Dometic GmbH, In der Steinwiese 16, D-57074 Siegen

FJ 1100, FJ 1700, FJ 2200

Creation of water condensation

fig. 1

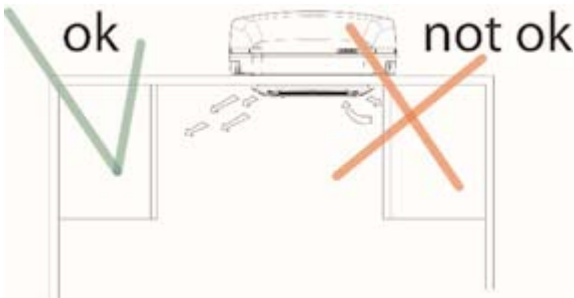
- Operating error: The choosen target temperatur is very low. The air conditioner is in continuous operating (e.g. choosen 18°C if the outside temperature is 38°C).
- Faulty sealing between air distribution box and roof top part.
- Open door and windows.
- Wrong installation of the air conditioner. The air can't circulate in the right way (fig. 1).

fig. 2

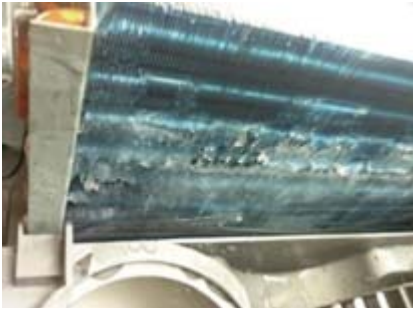
This can be validated by the plastic wall in the front of the air conditioner (fig. 2 + 3). If this plastic wall is missing, the kits 1 (81-BB-36601) and 2 (81-B-36602) must be installed to avoid ice formation on the evaporator (fig. 3) and the creation of a lot of condensation water on the fan (fig. 4).

At first it must be checked whether the condensation kit 1 (81-BB-36601) is installed already.

The condensation kits 1 (81-BB-36601) and 2 (81-B-36602) can be ordered via the Dometic sales companies.
